NEXT GEN NAVIGATION CADNAV1

TECH UPDATE – 2015 GM Video Cable (LVDS)

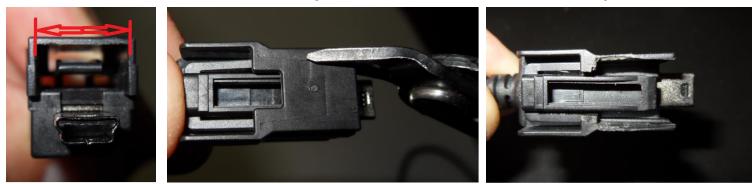
Complaint: The LVDS Cable from the Nav Box will not plug into the monitor.

Issue: GM made a slight difference in the Video Cable Connector for 2014.5 and 2015 models.

The cable on top is the included cable with The CADNAV1, in the second picture the difference on

the new OEM plug is highlighted.

Solution: We will be changing out the cable in future product but a slight modification in the field will correct the situation.

On the included LVDS Video cable you will need to trim the top plastic material with a small set of nippers.

Remove ONLY the Shown below portion; do not remove the retainer clip inside.
